Department of State Growth

Clarence draft Local Provisions Schedule hearing - further information directions

Attachment – Further information table

The map below is an example on the East Derwent Highway at Geilston Bay where the mapping provides a reduced buffer.

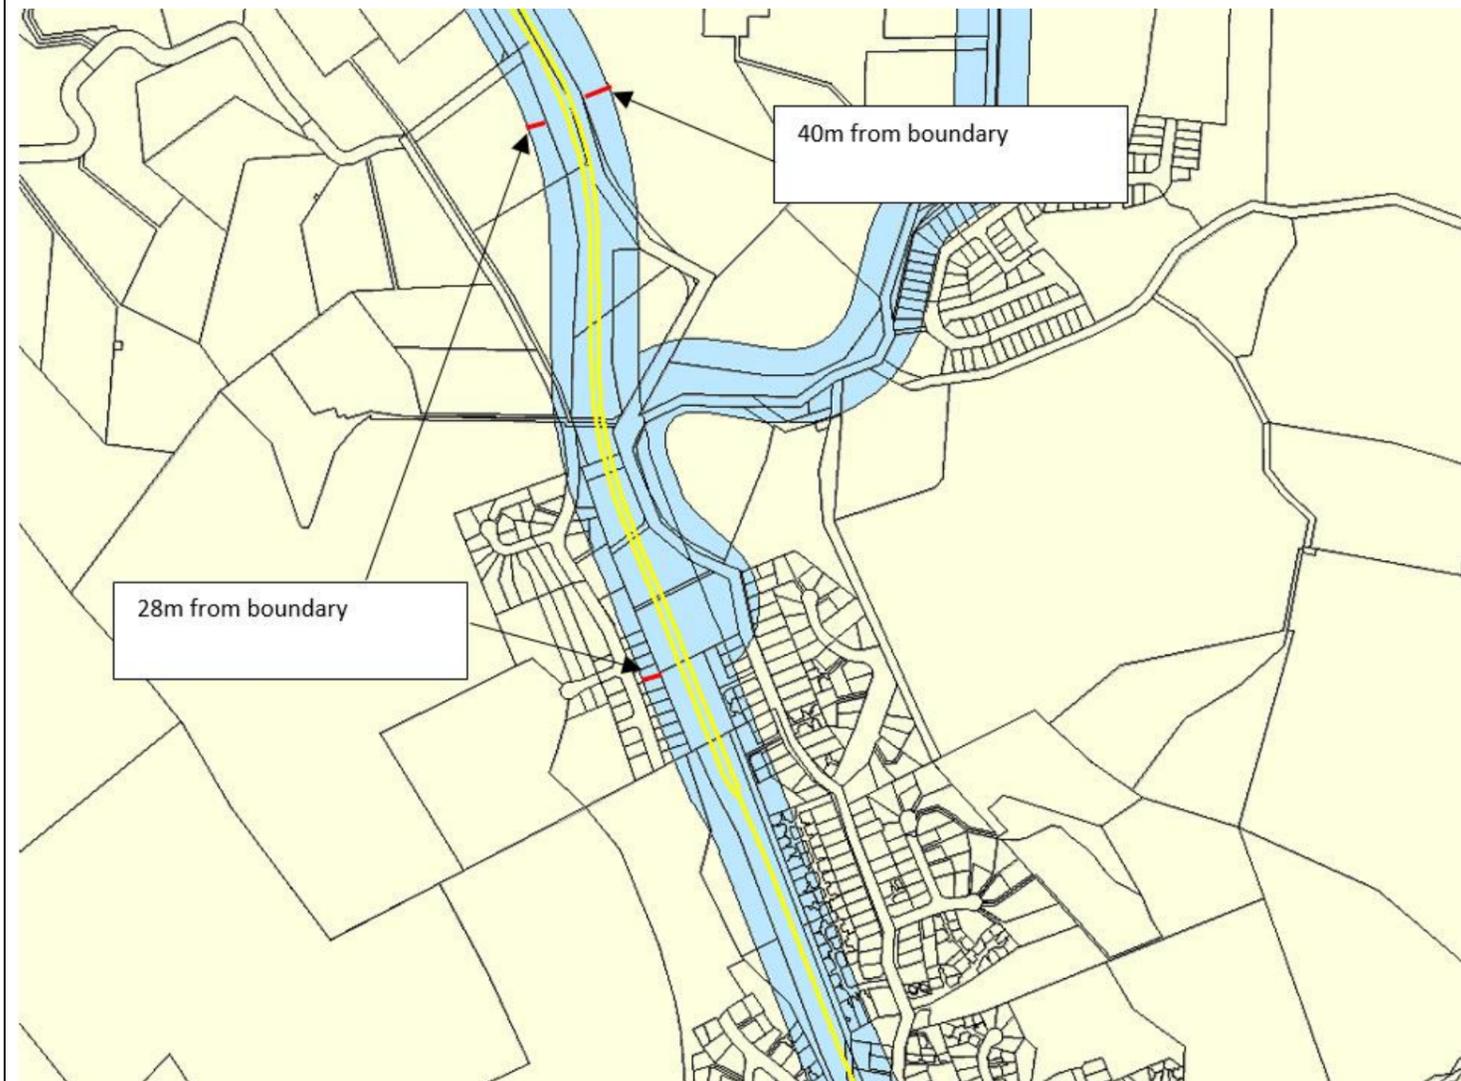
| Direction | Response |
|--|---|
| <p>2.3 Advise which (if any) sections of the road or railway attenuation area overlay are inaccurate, with reference to the definition of the road or railway attenuation area in the Road and Railway Code of the State Planning Provisions (SPPs) and the Department's casement mapping.</p> | <p>State Growth considers that the attenuation area as mapped by Council reduces the protections that would be available compared to relying on the road definition which extends to the whole width of the reserve "between abutting property boundaries".</p> <p>By comparison, Council's overlay appears to be based on a 50m buffer from the road centerline in many cases.</p> |

This is concerning for State Roads particularly if applied to Category 1 and 2 roads which are multi lane, wider roads and which could lead to development, without attenuation requirements, closer to the road boundary. Category 1 and 2 roads are important freight networks and significant generators of noise, air and light impacts.
